SUBJECT: REQUEST FOR ADDITIONAL INFORMATION FOR THE MODEL NO. HI-STAR
100 TRANSPORTATION PACKAGE

Docket No.: 71-9261
TAC No.: L23796

HI-STAR 100 TRANSPORT SYSTEM
DOCKET NO. 71-9261
TAC NO. L23796
REQUEST FOR ADDITIONAL INFORMATION

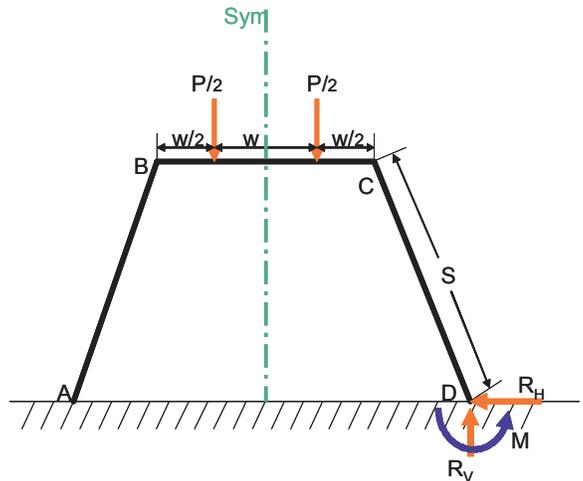
2-2 Correct the expression and the calculated value for the maximum bending moment for the fuel basket Angle Support.

In Page 2-AD-11 of the “STRUCTURAL CALCULATION PACKAGE FOR MPC,” Report No.: HI-2012787, the following expression for the moment at point C is derived based on an assumption of hinged connection at point D.

$$M_C = \frac{9}{16} \frac{PW^2}{3W+S}$$

Using $P = 6151$ lb and $W = 0.531$ in., and $S = 4.05$ in., the resulting value for M_c is 173 lb-in/in.

However, the staff believes the reaction moment at D was overlooked in the report (i.e., D is assumed hinged, rather than clamped).

Based on the assumption of clamped joint at point D, the expression for the moment at point C would be:

$$M_C = \frac{3}{4} \frac{PW^2}{4W+S}$$

which results in 210 lb-in./in. Therefore, the value calculated by Holtec appears to under predict the moment at point C by 21%.
